APRIL 2021

TRAILS AT ASPEN RIDGE				
ROADWAY & STORM IMPROVEMENT PLANS ROADWAY & STORM PLANS				
ROAD CENTERLINE KEY MAP				
DESIGNED BY:	TRC	SCALE	DATE ISSUED:	APRIL 2021
DRAWN BY:	LCB	HORIZ. 1" = 80'	SHEET	4 OF 50
CHECKED BY:	NMS	VERT. N/A		
				DRAWING No. RD00

TRAILS AT ASPEN RIDGE
FILING NO.3
ROADWAY & STORM IMPROVEMENT PLANS

DESIGNED BY:	TRS	SCALE		DATE ISSUED:	APRIL 2021	DRAWING No. GN02
DRAWN BY:	LCB	HORIZ.	N/A			
CHECKED BY:	NMS	VERT.	N/A	SHEET	3 OF 39

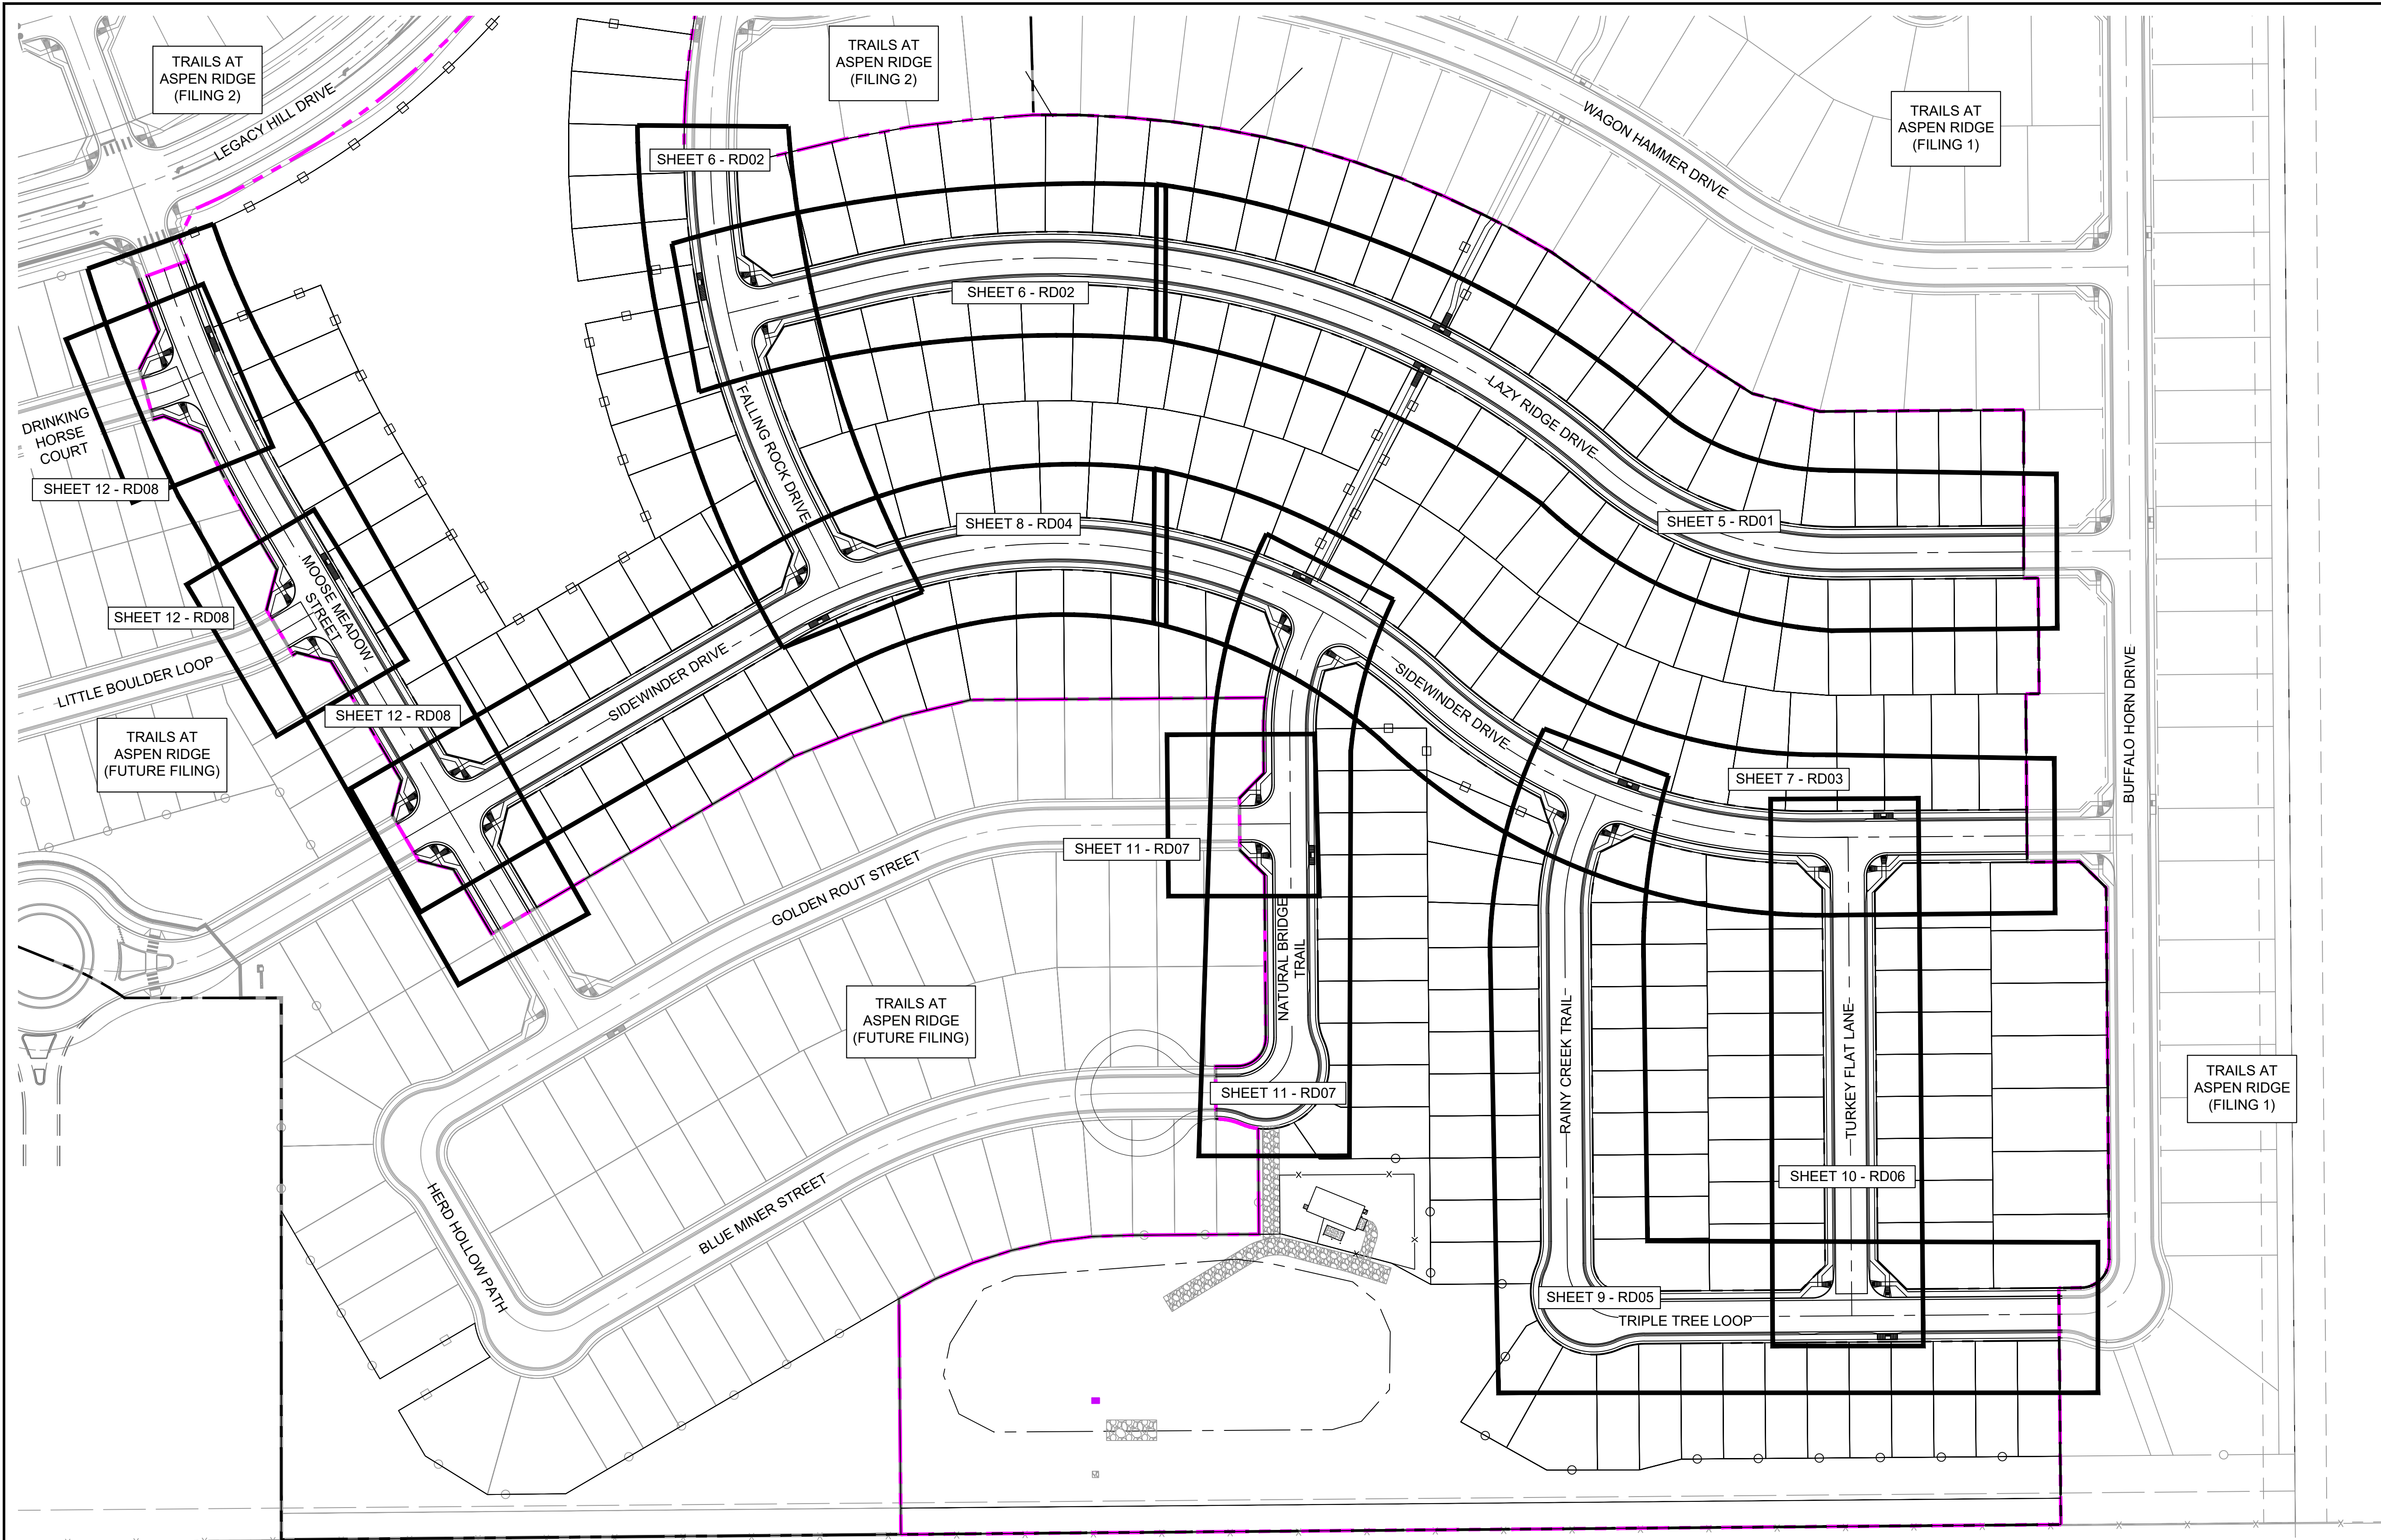
Add the notes from detail SD_2-26

TRAILS AT ASPEN RIDGE				
FILING NO.3 ROADWAY & STORM IMPROVEMENT PLANS				
STORM DRAIN PLAN & PROFILE				
DESIGNED BY:	TR	SCALE	DATE ISSUED:	DRAWING No.
DRAWN BY:	LCB	HORIZ 1" = 40'	APRIL 2021	SD01
CHECKED BY:	NMS	VERT. 1" = 5'	SHEET 31 OF 39

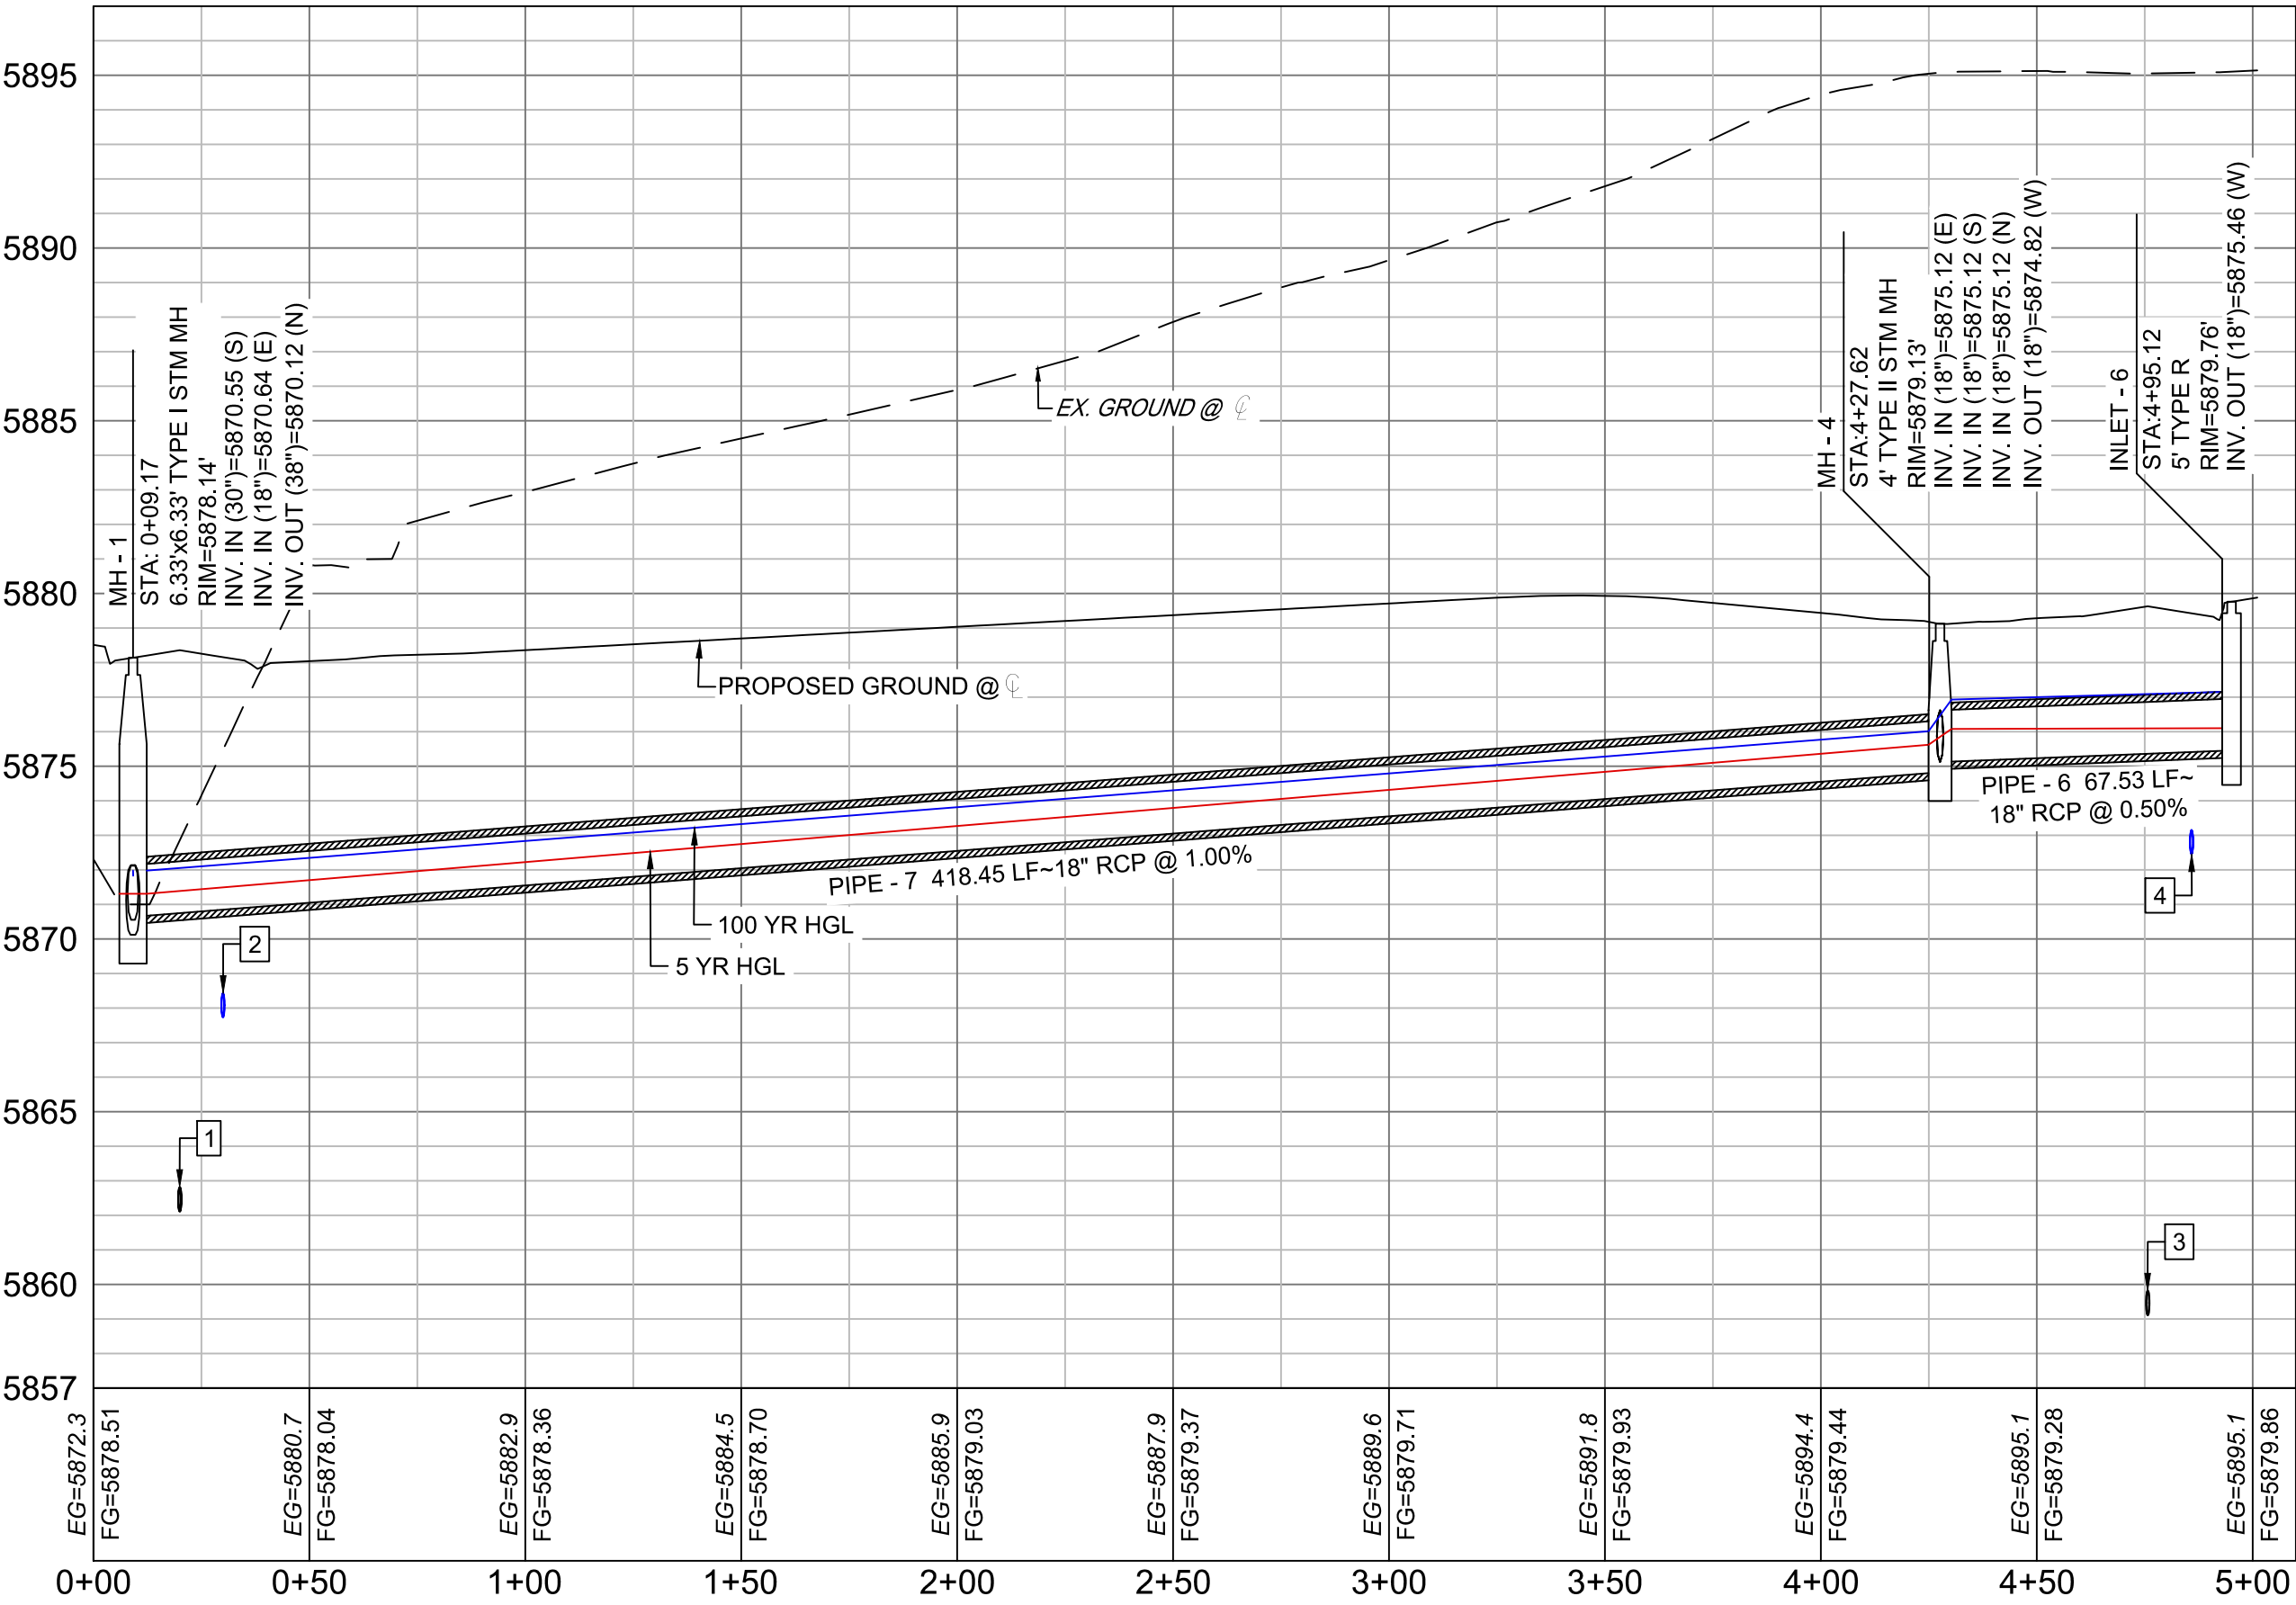
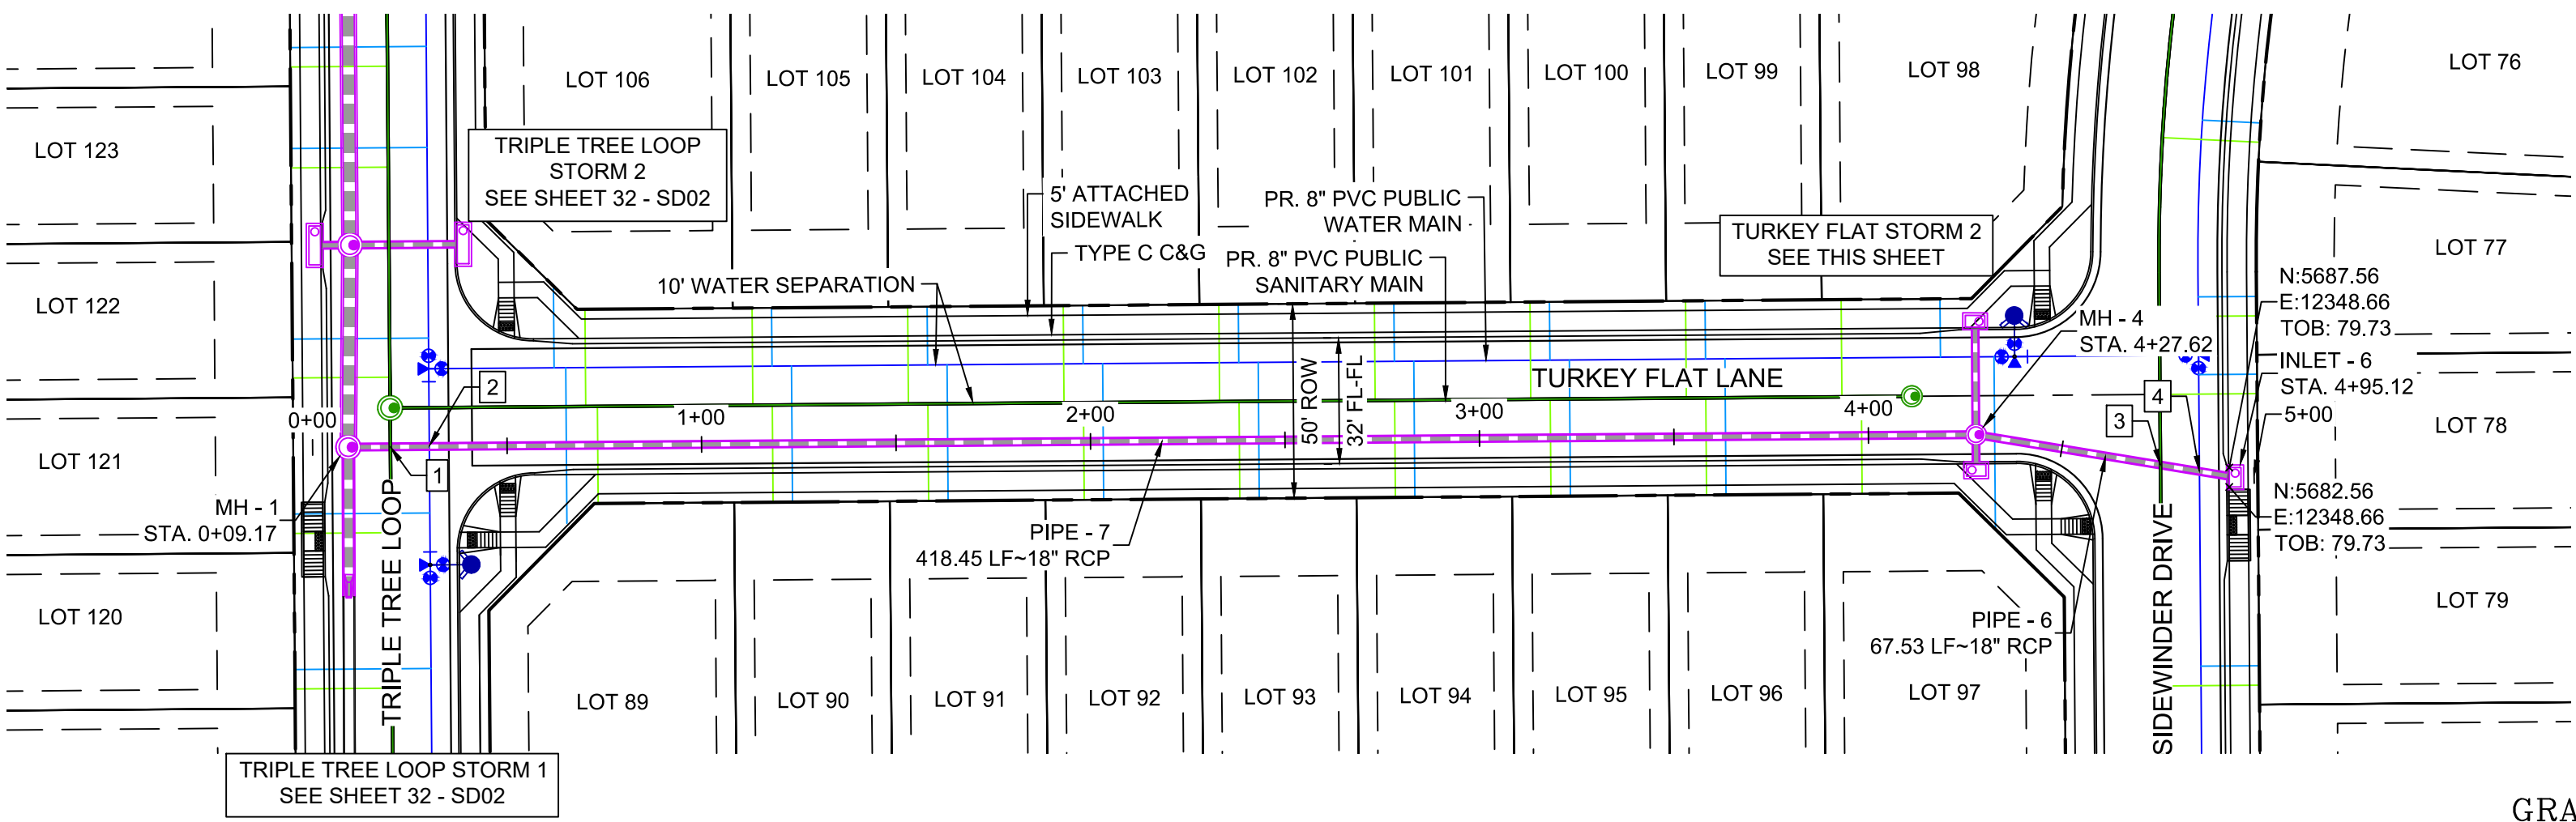
Add the following note:
Sections of storm pipe with pressure head during the 100yr storm shall use watertight joints with a 100 yr service life per ECM 3.3.1.D
